# Technical Bulletin

## No: 121 – Output Board Modification for use with “Super Clock”

<b>RADIO SYSTEMS</b> Bridgewater, NJ, U.S.A.	Title:	
	OUTPUT BOARD	
Product: R.S. SERIES CONSOLE	Type:	
	CIRCUIT BOARD	
Size:	Code:	Part #: 8074
Scale:	Rev. #: 1	Sheet 1 of 1

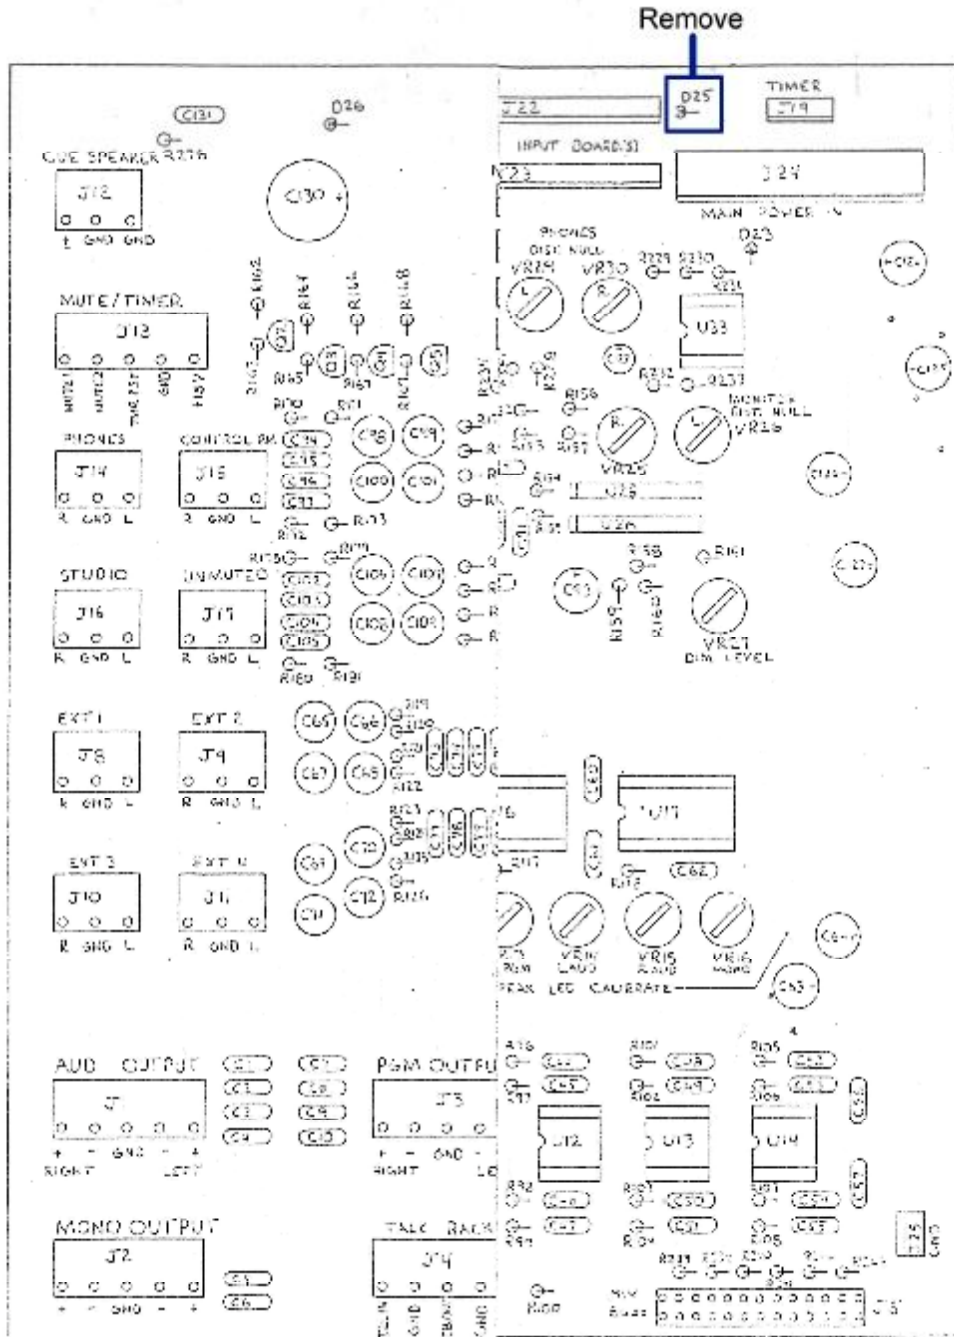
1. Remove D25
2. Run a jumper wire from J-13-3 to J19-1
